**CITY OF LA VISTA
MAYOR AND CITY COUNCIL REPORT
MARCH 4, 2025 AGENDA**

Subject:	Type:	Submitted By:
PLANNED UNIT DEVELOPMENT – SITE PLAN AMENDMENT HAUSMANN HOLDINGS, LLC	◆ RESOLUTION ORDINANCES RECEIVE/FILE	CALE BRODERSEN ASSOCIATE CITY PLANNER

**CITY OF LA VISTA
PLANNING DIVISION
RECOMMENDATION REPORT**

RE: Hausmann Construction Office Building Planned Unit Development
Initial Review Letter

8040 Eastport Pkwy
La Vista, NE 68128

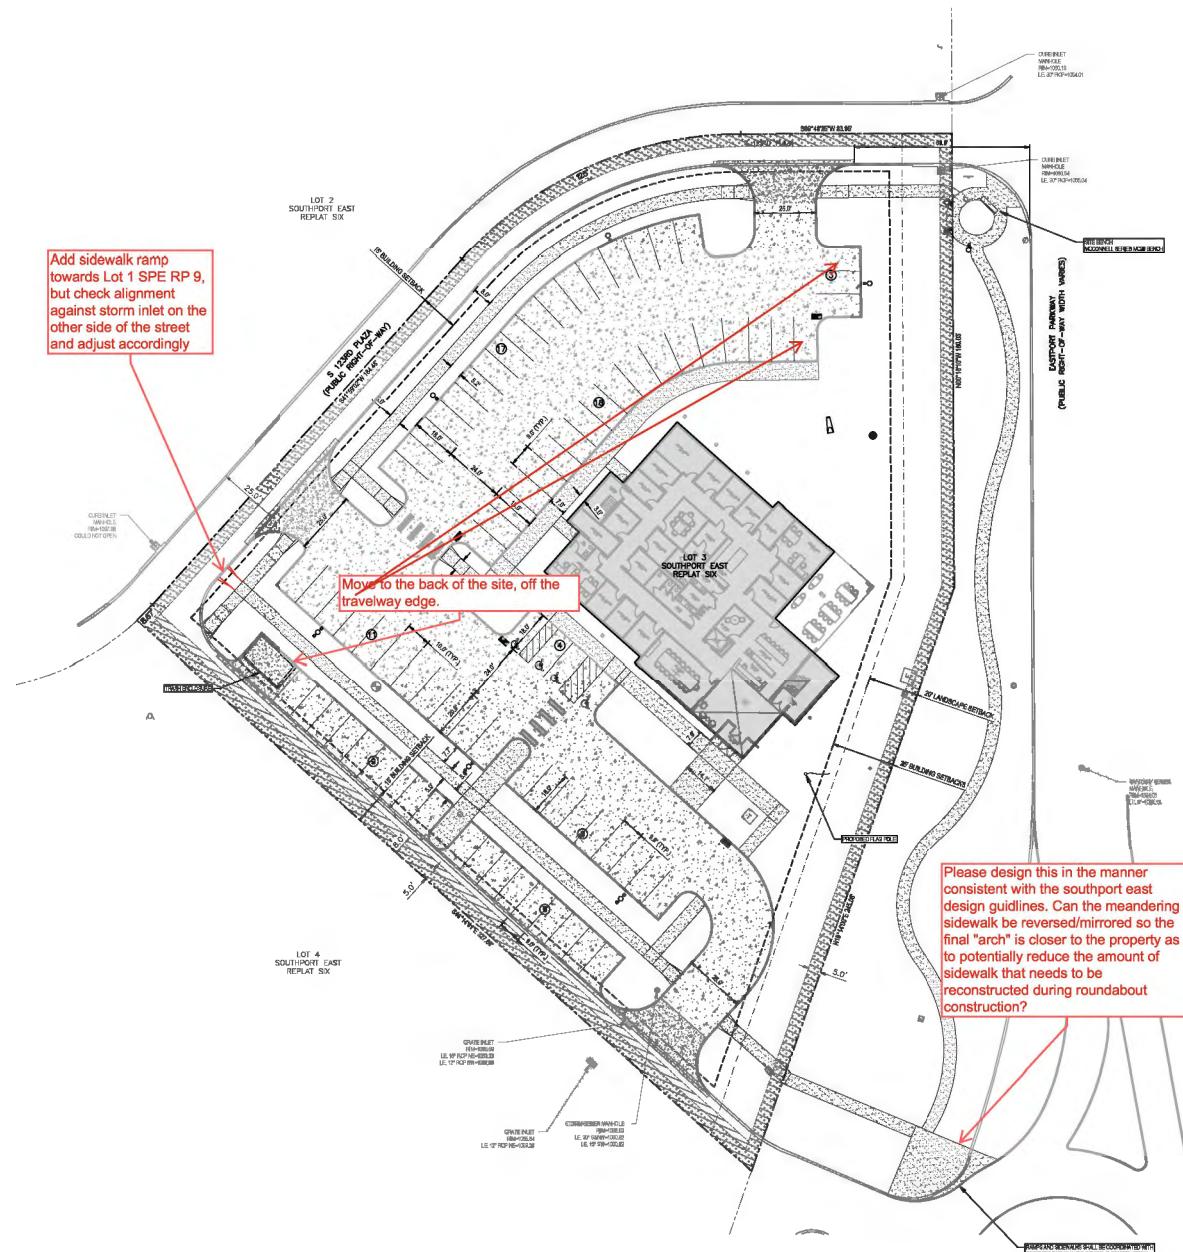
11. A flagpole is noted in the PUD site plan. This flagpole shall comply with Section 4.15.03 of the La Vista Zoning Ordinance.
12. Please design and construct the ramps and sidewalks adjacent to the proposed, future roundabout in a manner consistent with the Southport East Design Guidelines. The timing of this roundabout is uncertain, and the ramps and sidewalks can be reconstructed as part of the roundabout construction if necessary. Please design the meandering sidewalk in such a way as to reduce potential conflict with the roundabout and right of way.

13. We recommend relocating the dumpster enclosure to the northeast corner of the property to move it further from the travelway edge and the entrance of the building, as noted in the attached redlined site plan. Please confirm that waste hauler truck routing and turning movements are acceptable to properly service the trash enclosure.

14. Please include a sidewalk ramp for the sidewalk on the west edge of the property that directs toward Lot 1 Southport East Replat 9, and confirm that the alignment does not conflict with the storm sewer inlet on the other side of the street, as noted in the attached redlined site plan.

Add sidewalk ramp towards Lot 1 SPE RP 9, but check alignment against storm inlet on the other side of the street and adjust accordingly

~~Move to the back of the site, off the travelway edge.~~

Please design this in the manner consistent with the southport east design guidelines. Can the meandering sidewalk be reversed/mirrored so the final "arch" is closer to the property as to potentially reduce the amount of sidewalk that needs to be reconstructed during roundabout construction?

Response: The sidewalk and ramp area has been revised.

Response: Dumpster enclosure has been relocated to the northeast corner of the property.

Response: A ramp directed towards Lot 1 Southport East Replat 9 has been added. The alignment does not conflict with the storm sewer inlet on the other side of the street.
